Company	Trenz Electronic GmbH
PCN Number	PCN-20251026
Title	TE0808 Gap Filler Upgrade
Subject	BOM Change
Issue Date	2025-11-04

#1 Changed gap filler from GF3500S35-00-60-50CC to
GF4500CVO-00-240-50CC.

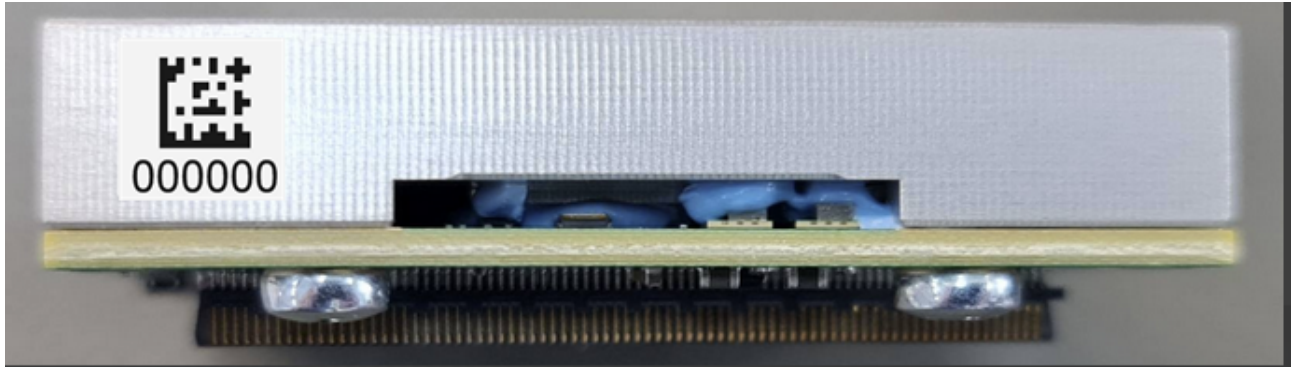
Type: BOM Change

Reason: Improve thermal conductivity.

Impact: Improved thermal conductivity. Changed colour from blue to pink. For more detailed changes consult gap filler datasheets.
